### ARCHITECTURAL REVIEW BOARD MUNICIPAL PLANNING COMMISSION -AGENDA-

#### MEMORANDUM

SUBJECT: Staff Memo for the Meeting of July 27, 2023

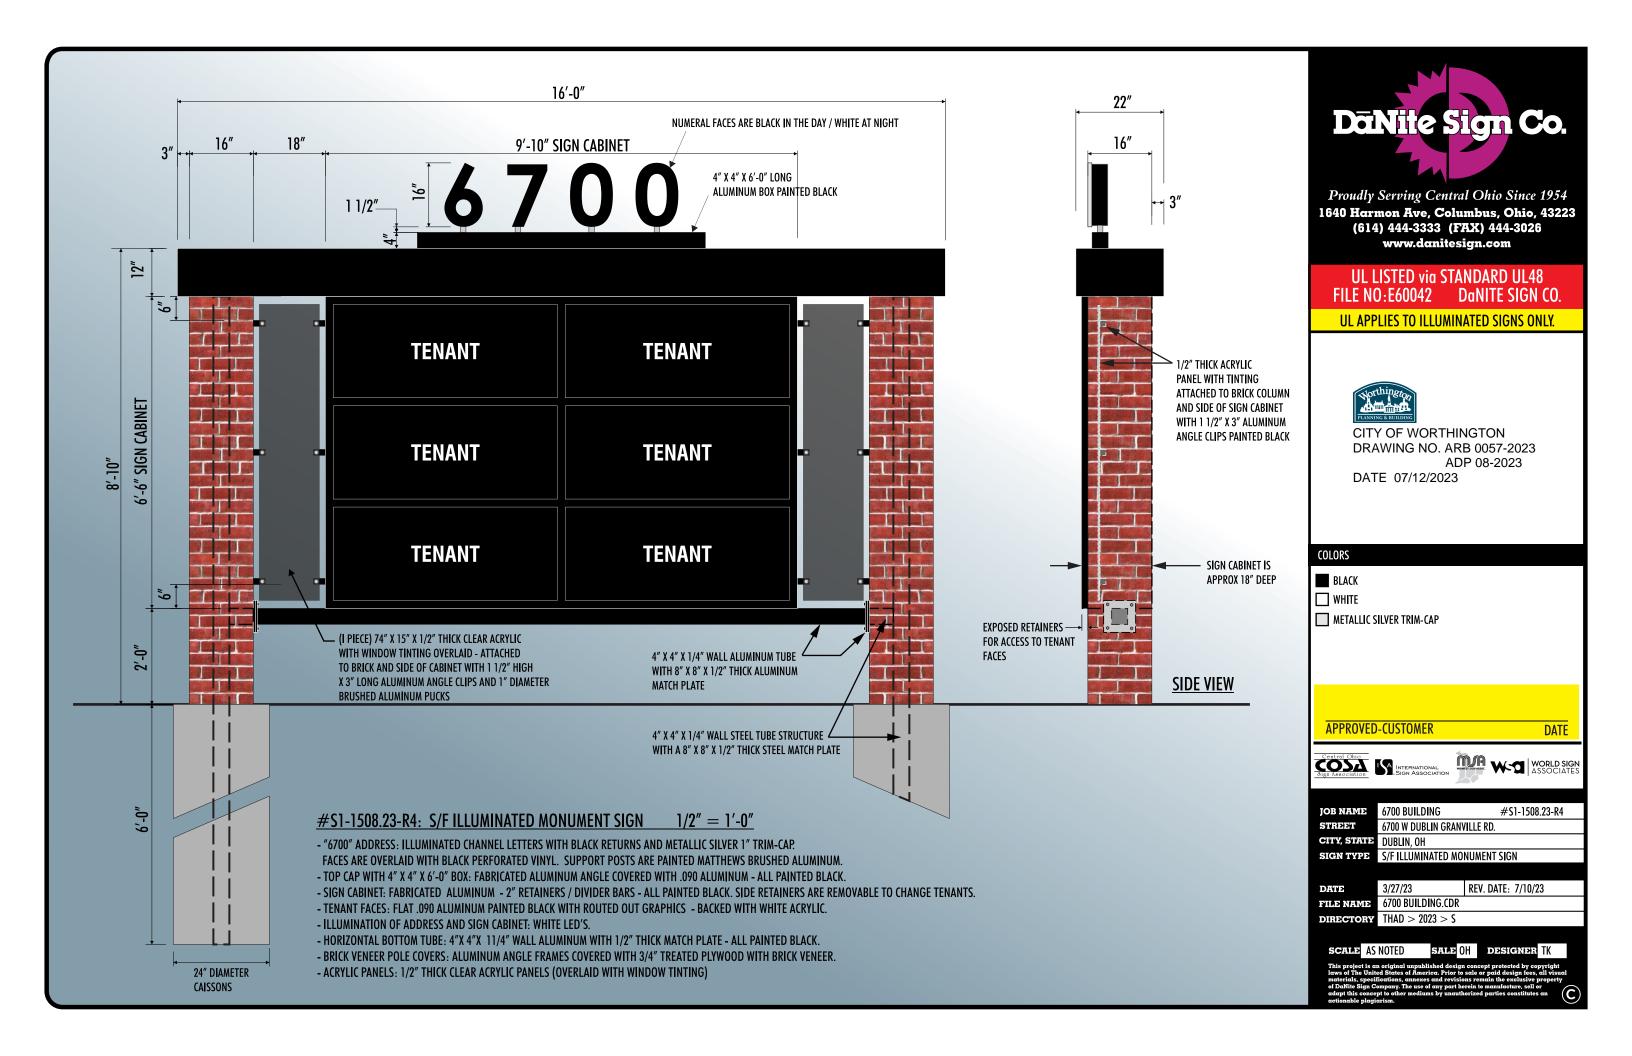
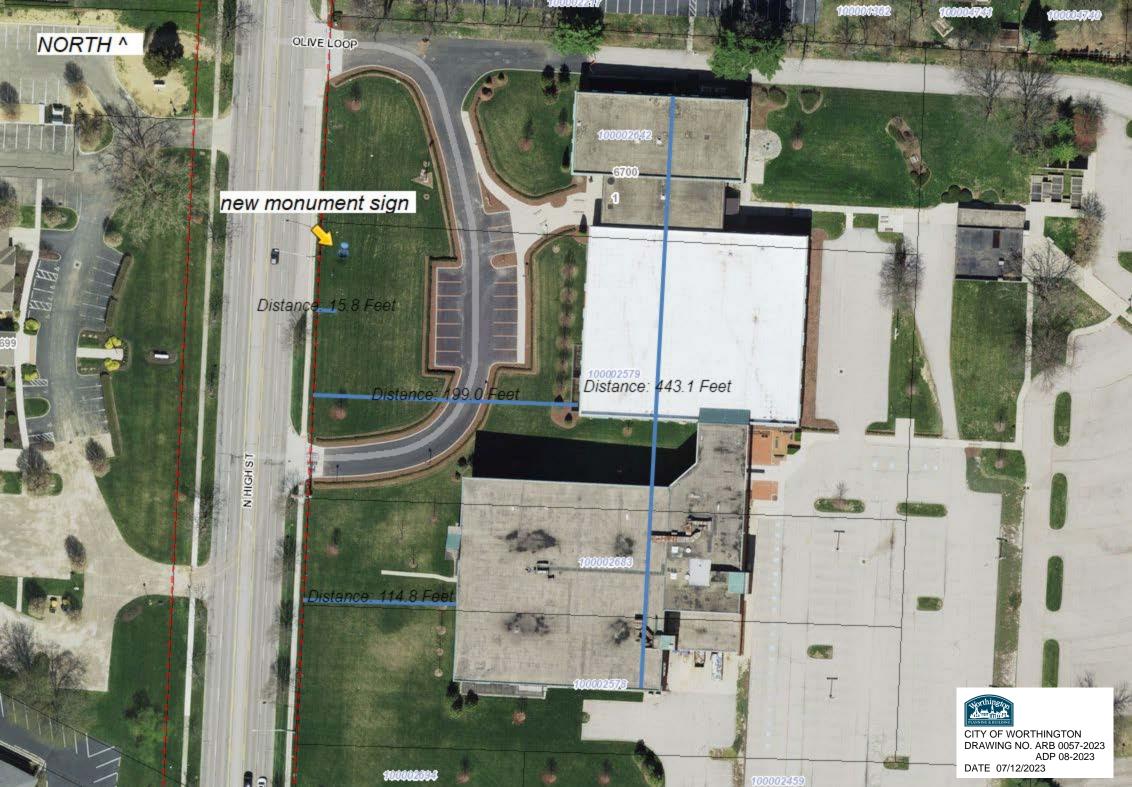
- 1. Although this is a large property, the proposed sign is so much larger than the other signs in the corridor it would look out of place. Simplification of the supporting structure may be warranted, for example: slightly wider brick columns and elimination of the acrylic panels; or a simple brick base and sign cabinet.
- 2. A sign cabinet with six tenant panels per side should be acceptable in a reduced size.

Redesign of the sign to simplify the look and reduce the overall size is recommended.
